Access Compliance Report Public Rights-of-Way (Curb Ramps)

Main Street: DORRANCE_DR Cross Street: PERCHERON_DR Location: NW

ADA ID: RPRK211112130337 Ramp Type: Type 1 - Perpendicular Initial Pass/Fail: Fail Overall Compliance: No Severity Score: 16

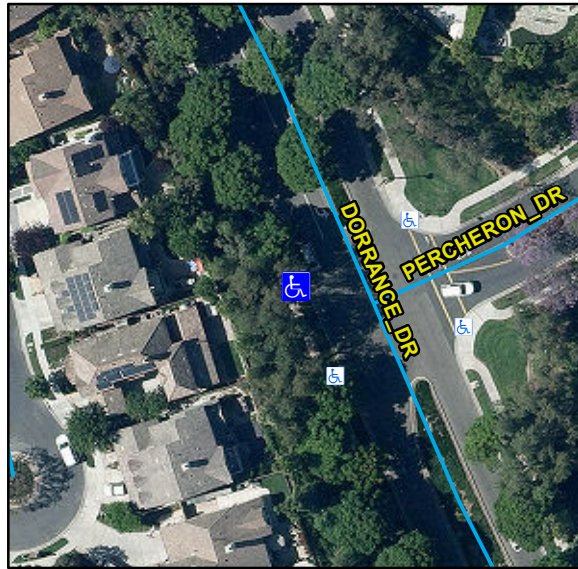
R204.3, R304.2.2, STD 1115

Remove & Replace Entire Ramp.
